**re:** **Excavation, Grading and Drainage Plan Review**  
**Proposed Residential Development**  
**100 Steacie Drive, Ottawa, Ontario**

**file:** PG5788-MEMO.03 Revision 3

Project		PG5788 - 100 Steacie Drive	
	Group		Section A - Static Analysis	
	Drawn By	PT	Company	Brigil
	Date	04/2026	File Name	Slope Stability Assessment

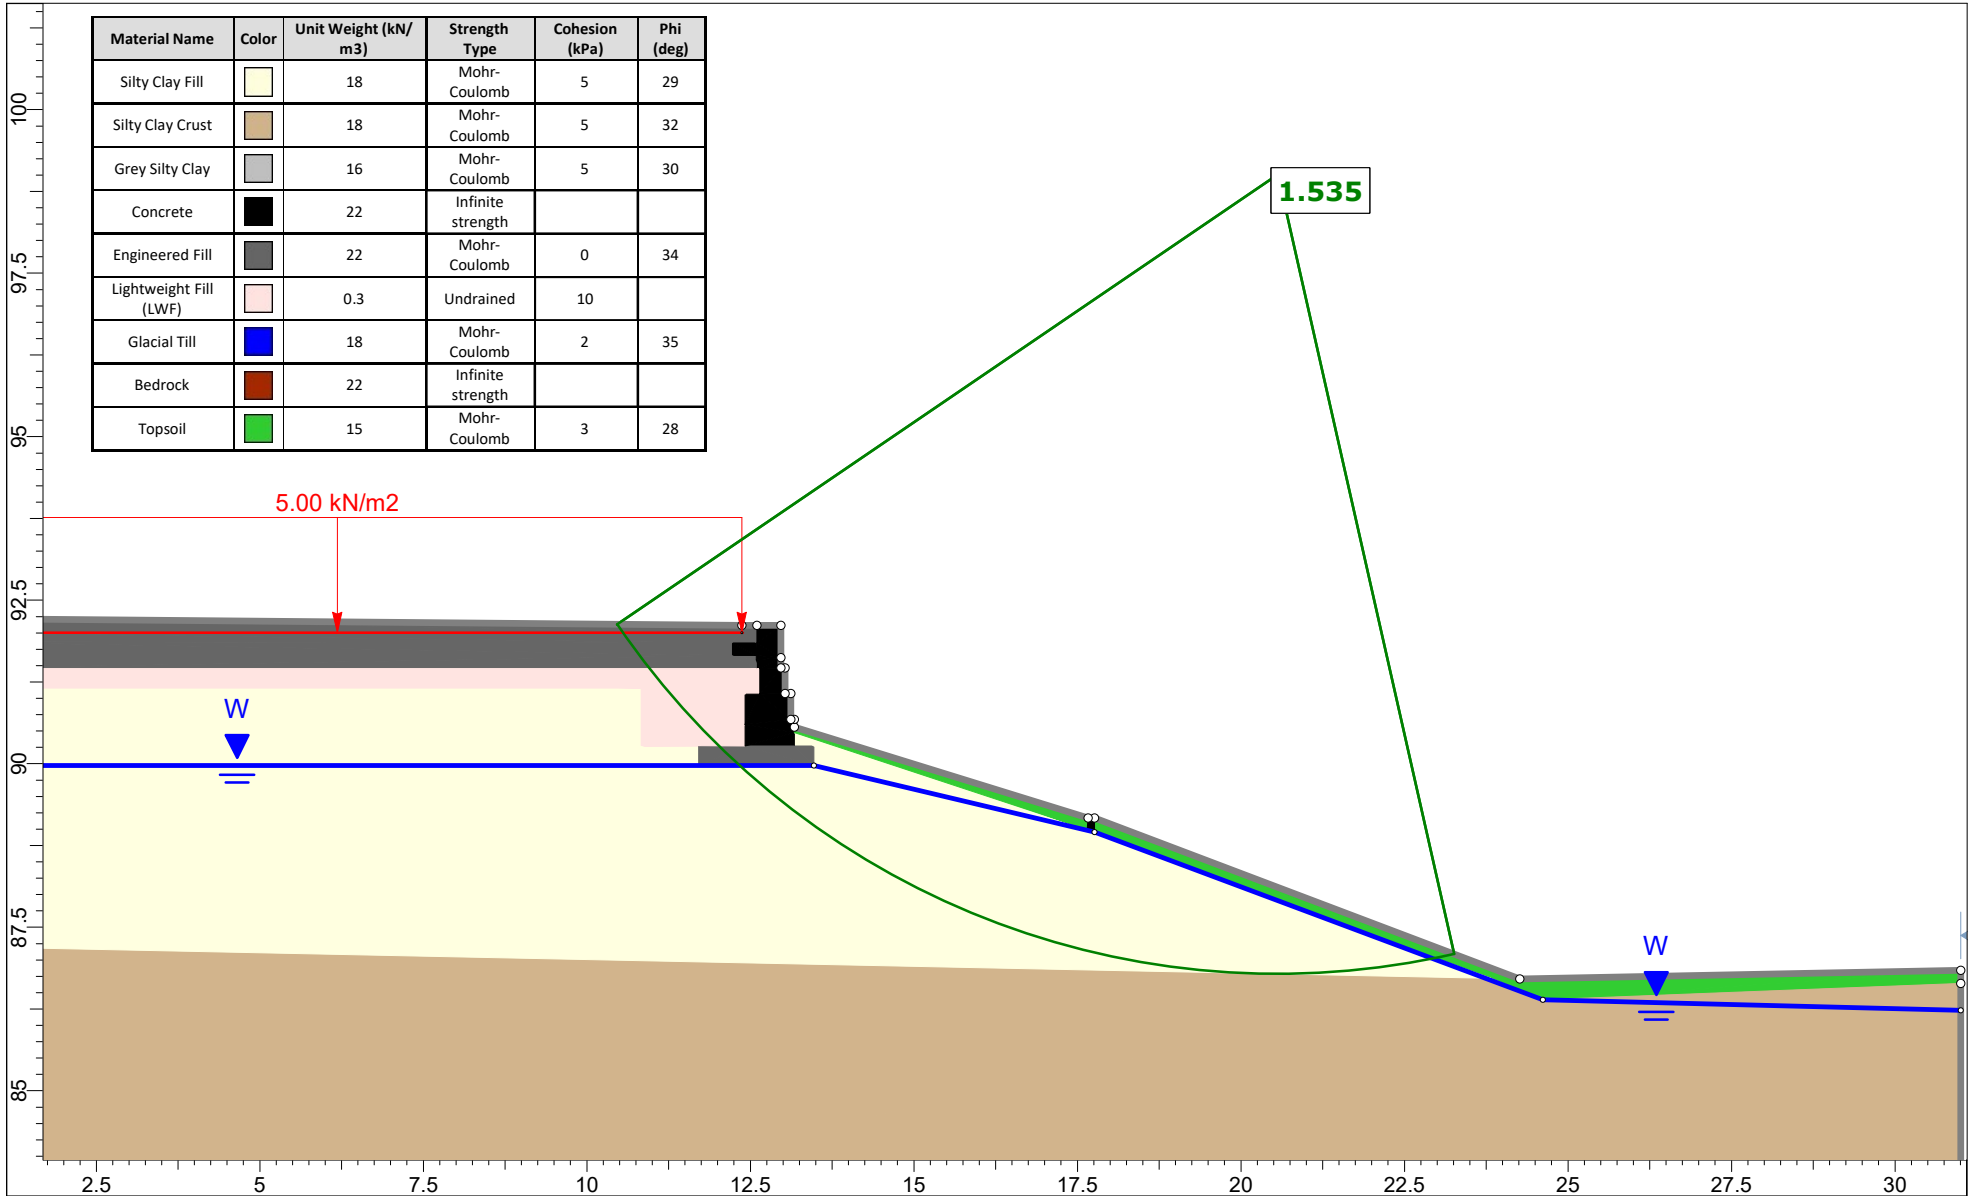
The static and seismic analysis results for slope cross-section A are presented in the figures attached below. In summary, the factor of safety for the slope was more than 1.5 under static conditions and more than 1.1 under seismic conditions.

**LIGHTWEIGHT FILL DETAIL**

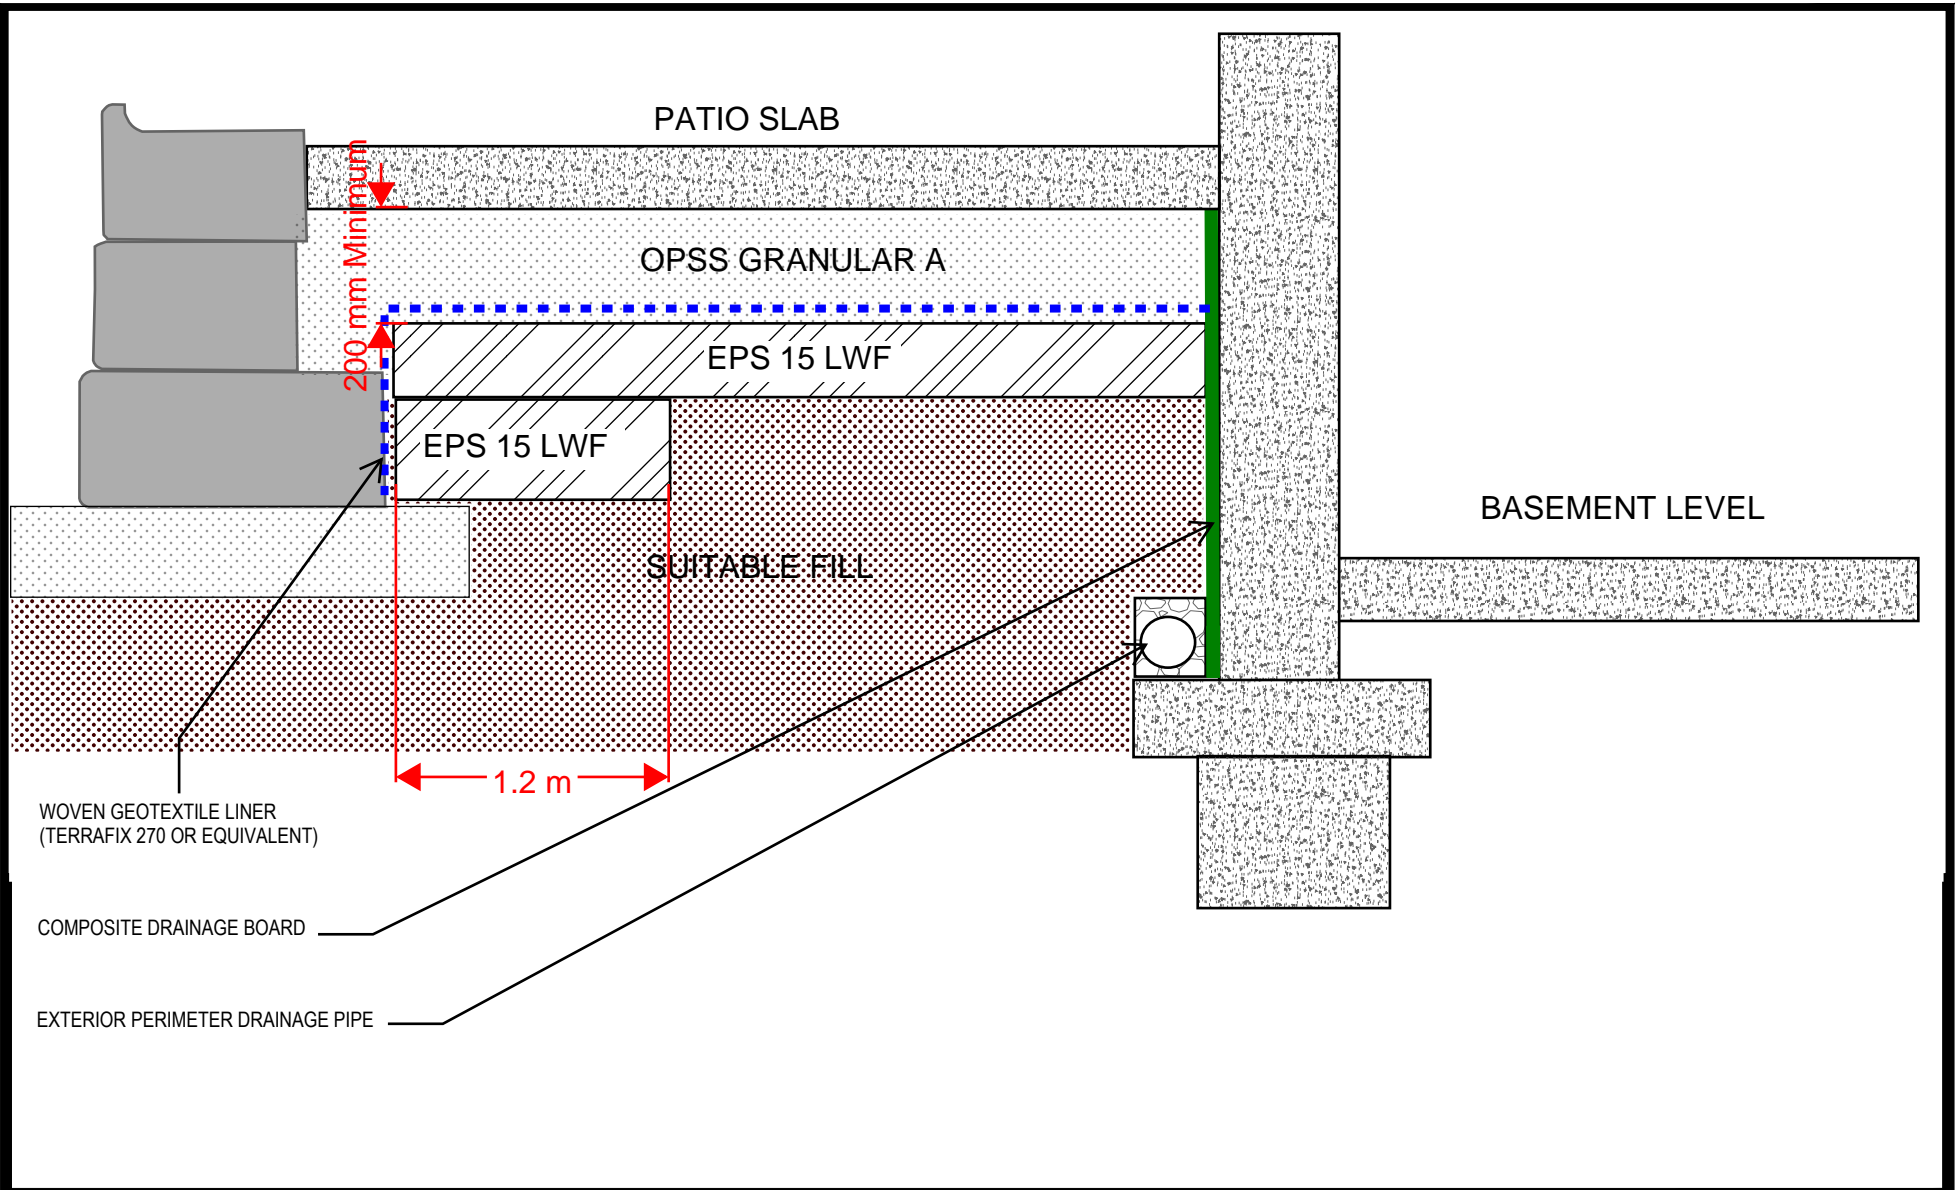
To mitigate the settlement in the landscaping areas, some lightweight (LWF) will be required surrounding the proposed retaining walls and the hardscaped areas located along the north and northeast side of the building. The LWF material should consist of EPS 15.

Reference should be made to the attached grading plan markup and LWF details attached below for the required LWF thickness within the respective areas.

It is not recommended to plant medium to large trees directly above the LWF EPS. The EPS should be covered with a polyethylene sheet and surrounded with a non-woven geotextile such as Terrafix 270R.

A minimum of 200 mm of OPSS Granular A should be placed above the LWF under the hardscaped areas and a minimum 200 mm of approved fill material and a minimum of 100 mm of topsoil should be placed under landscaped areas.
